Addendum No. 3
Solicitation 25-99841
2026 Parks Signage

This addendum serves to notify all bidders of the following changes to the solicitation documents:

SHEET TITLE / SIGN TYPE: B7- TABLE TOP MAP AND EMERGENCY SIGN	DATE DRAWN: June 18, 2019	DATE REVISED:	SHEET #:
PROJECT NAME/NUMBER:		 Hoisington Koegler Group Inc. 123 North 3rd St, Suite 100 Minneapolis, MN 55305 Phone: 612.338.0800 Fax: 612.338.6838

SHEET TITLE / SIGN TYPE: F3 SERIES REGULATORY SIGN	DATE DRAWN: June 18, 2019	DATE REVISED:	SHEET #:
PROJECT NAME/NUMBER: DWP Trail		Hoisington Koegler Group Inc. 123 North 3rd St, Suite 100 Minneapolis, MN 55305 Phone: 612.338.0800 Fax: 612.338.6838

1
B7 SIGN B7 - ELEVATION
N.T.S.

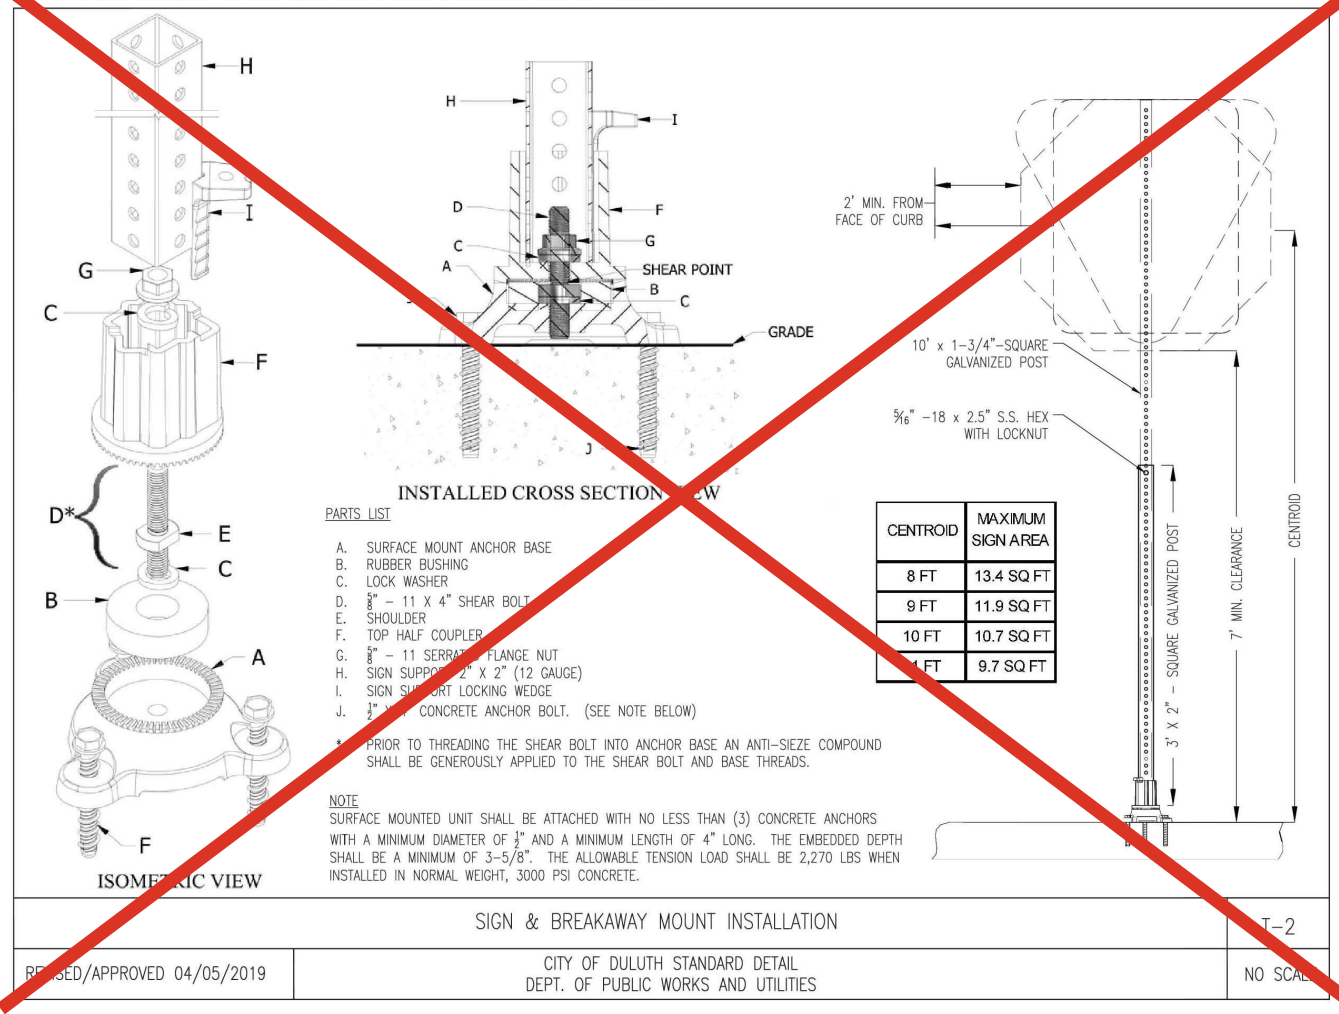
1. CLARIFICATION – The drawings in the plan set for signs F3 and B7 had errors. Please note that signs F3 and B7 do NOT require concrete footings, nor are there any existing footings. Strike pages 27 and 29 from the Bid Packages and replaced with the documents attached to this Addendum labeled 'Exhibit A'.

2. *Type F3. If footings are required, please provide details.*
 - a. No footings are required for F3 and B7 signs. See attached document 'Exhibit A'.
3. *Type B7. Drawing notes see footing detail 1 / FT; where can we located this detail?*

4. *Type B7. Elevation notes galvanized u-channel posts, "City standard mount installation detail" shows perforated square galvanized post mounted to a break away. Which is accurate?*

- a. The footing detail was an error from a prior project and will be struck from the bid package. Please see the attached document labeled, 'Exhibit A'.

- a. All B7 and F3 signs in this package will be mounted on u-channel galvanized steel post, direct buried, and do not require any additional footing. See the attached documents to this addendum.

- a. All F3 and B7 signs in this package do not require mounting into concrete, nor is there existing footing. They will be mounted on galvanized u-channel posts directly buried into the ground. All F3 and B7 signs in this package are outside of street ROW, and may be galvanized steel u-channel post, direct buried 3+ feet. A standard method of "splicing" (or overlapping) u-channel signposts involves bolting two shorter posts together (typically with 12-18 inches of overlap). Example- direct bury 4-foot u-channel 3 feet into ground, leaving 1 foot exposed; splice another u-channel to reach desired sign height.

Mount sign to galvanized steel u-channel post, direct buried 3+ feet
